# Access Compliance Report

## Public Rights-of-Way

### (Pedestrian Signals)

Intersection ID: N/A	Main Street:	Cross Street: N/A	Location: N/A
ADA ID: BC99BD039A53	Signal Type: One Push Button-Non APS	Overall Compliance: No	Severity Score: BTN 1: N/A BTN 2: N/A No BTN: N/A
Codes/Mitigation Info/Possible Solution		Field Measurements/Component Compliance

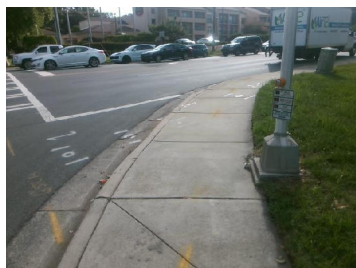
Surveyor Notes: TEXT HT 1/2"

PROW/ADA: R410.6, TMUTCD 4e.08, R404.2, R404.3, R404.7.3

Possible Solutions: Replace Signal Push Button With APS Button on New Post. Remove & Replace Sign.
